A318/A319/A320/A321

TITLE : AIR CONDITIONING - AVIONICS VENTILATION - INTRODUCE SEPARATE AVIONICS
VENTILATION DRAINAGE.

This page transmits Revision No. 04 of Service Bulletin No. A320-21-1113

SERVICE BULLETIN No. : A320-21-1113

Figure 4 Sheet 1
Installation of the Drain Tube, Config. 01, 02, 03, 04, 05 and 06

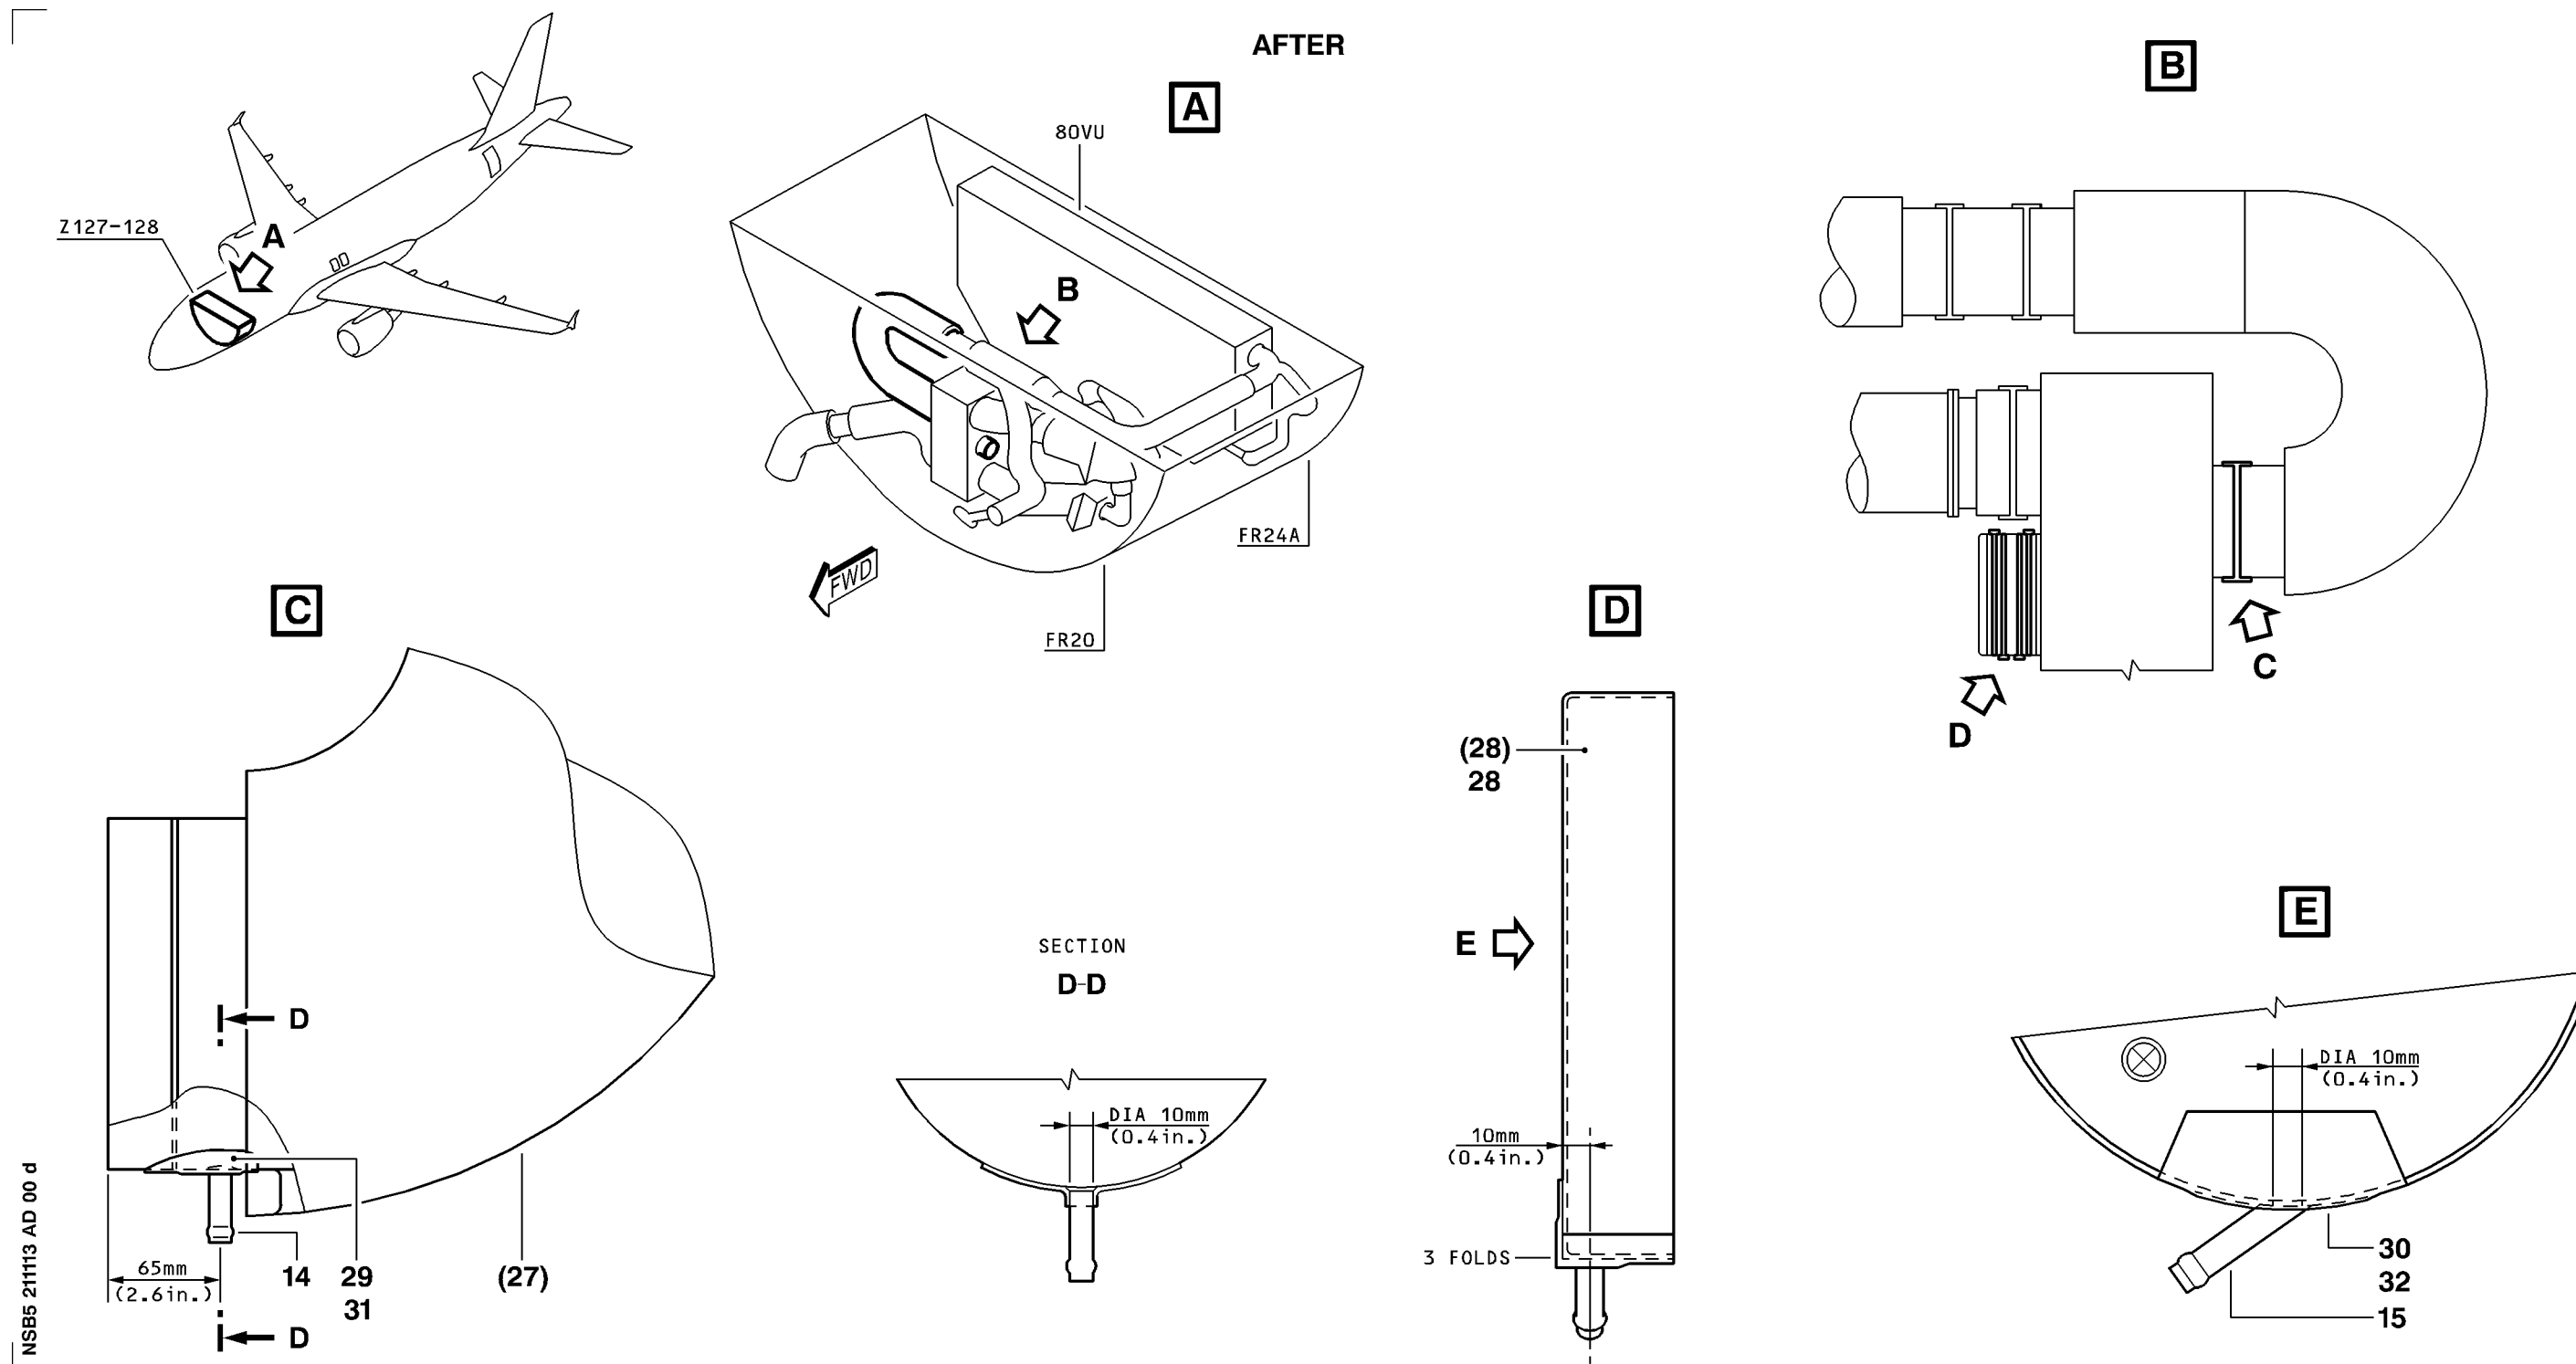
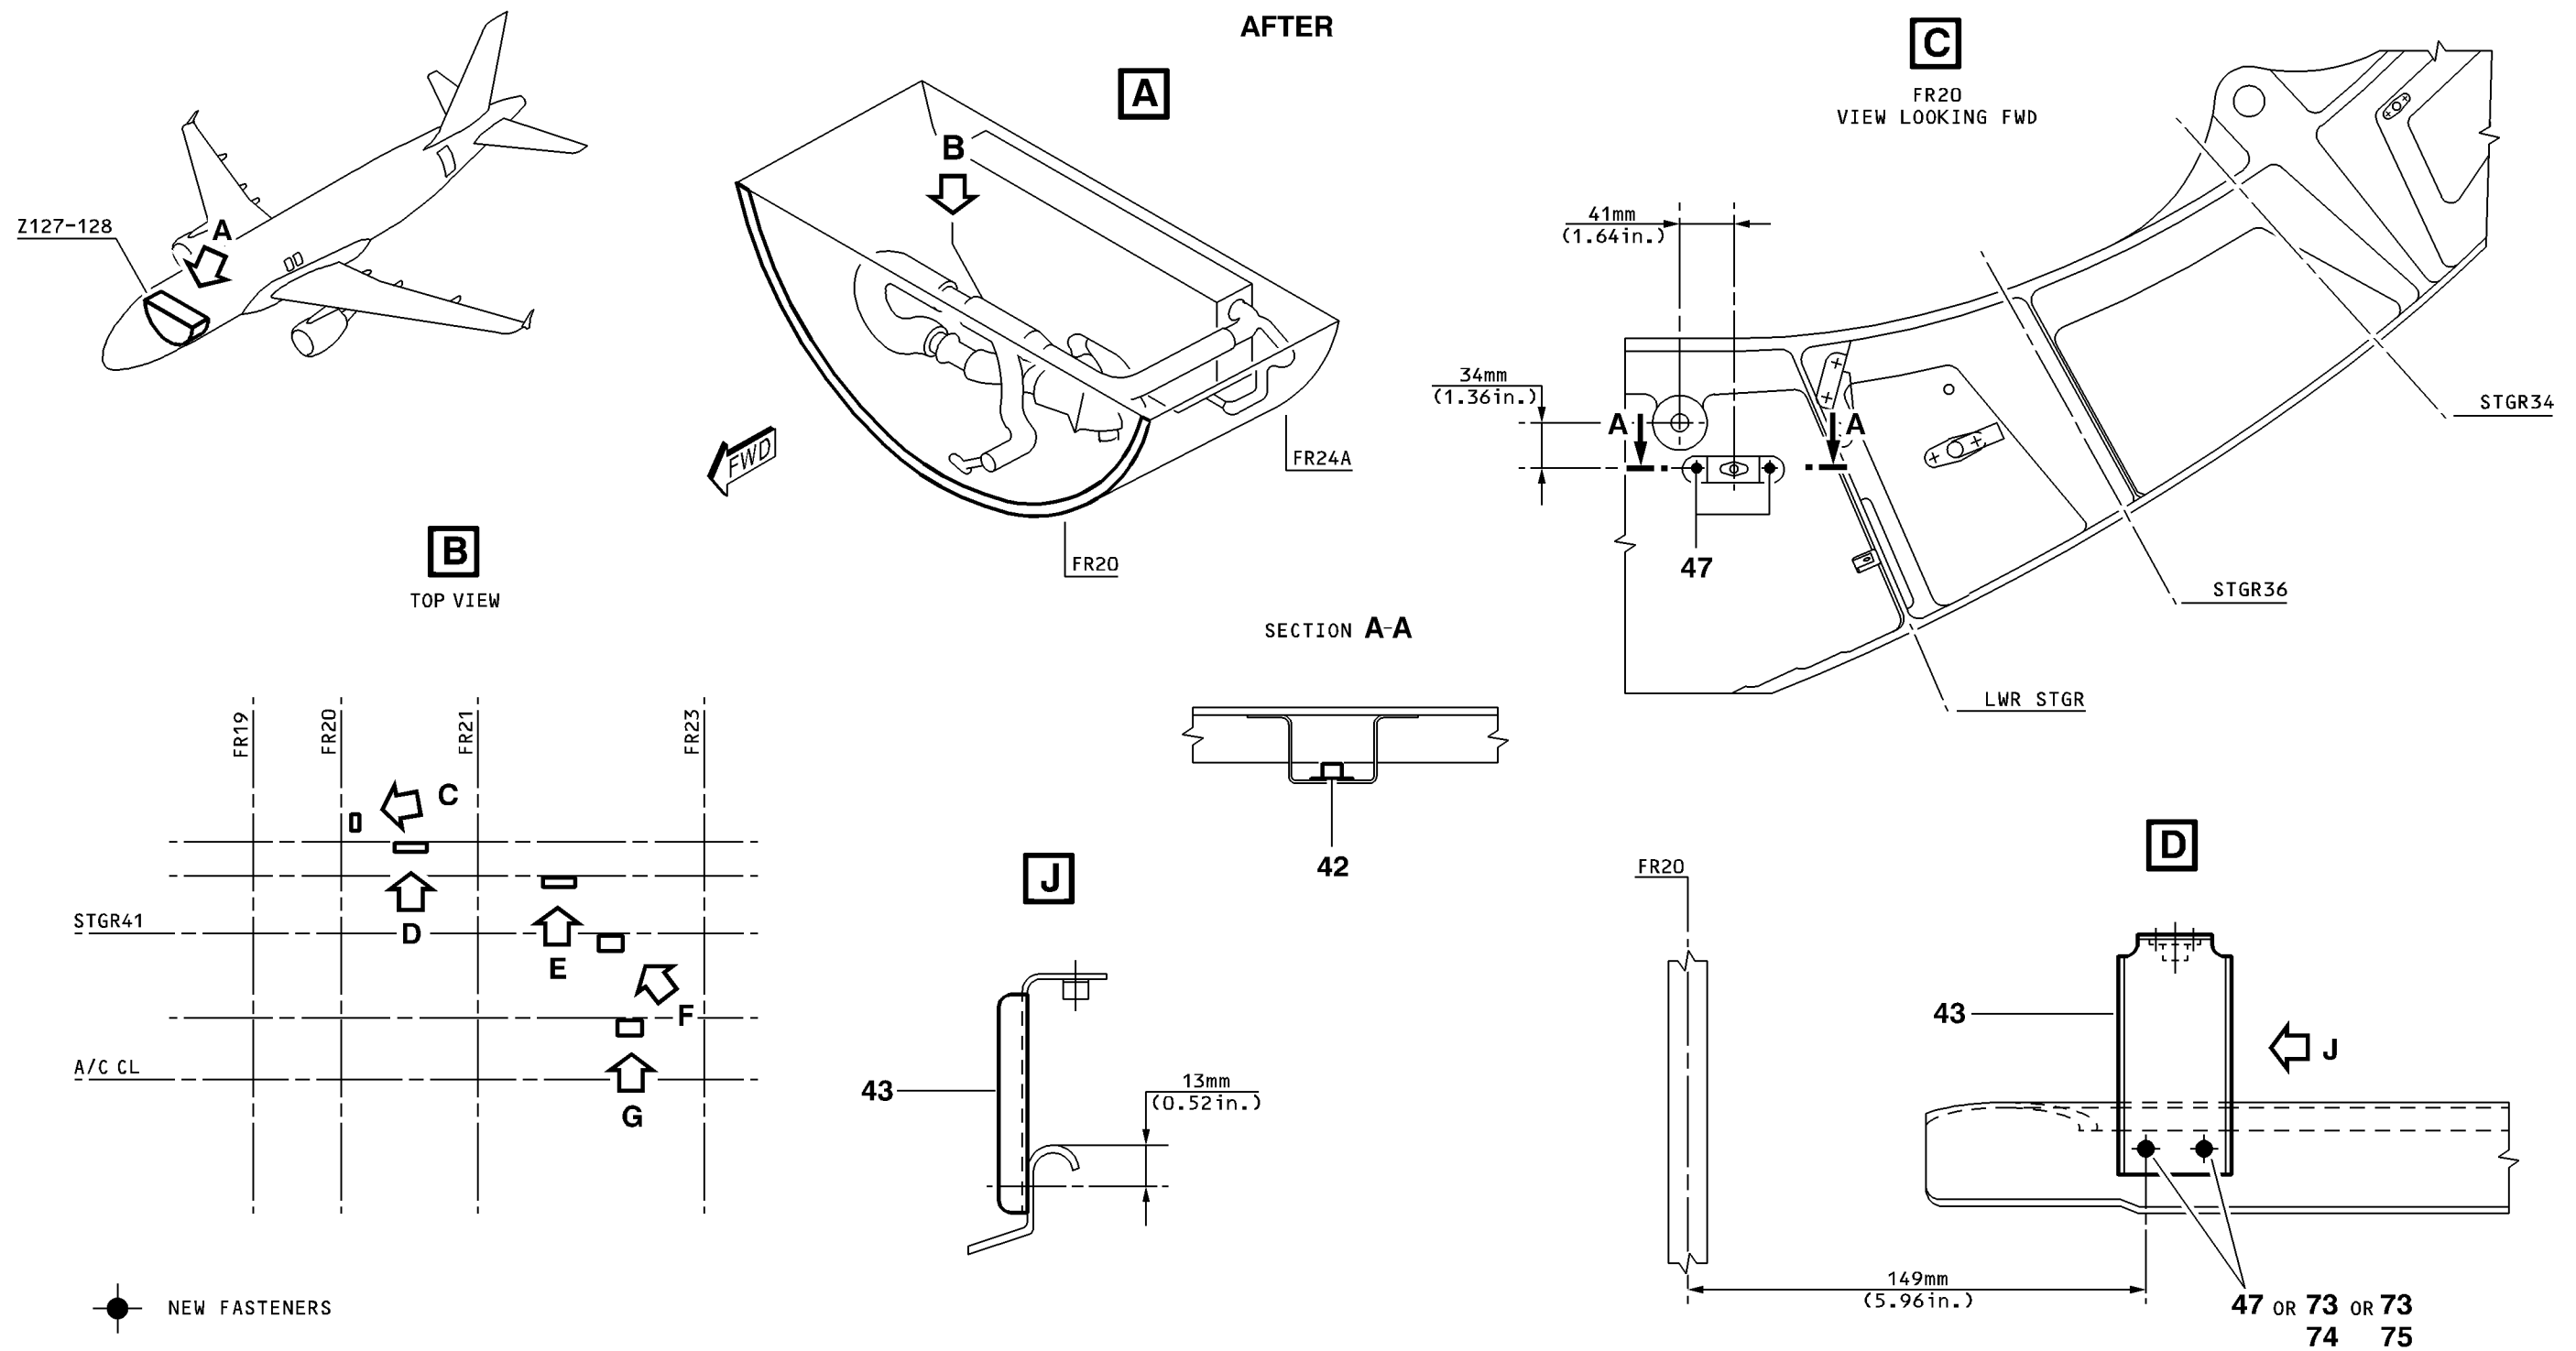
- . Title updated.
- Figure 4
 - . Title updated. Sheet 2, Items 73 to 75 added.
- Figure 5
 - . Title updated.
- Figure 6
 - . Title updated. Sheet 2, Items 73 to 75 added.
- Figure 7
 - . Title updated.
- Figure 8
 - . Title updated.
- Figure 9
 - . Title updated.
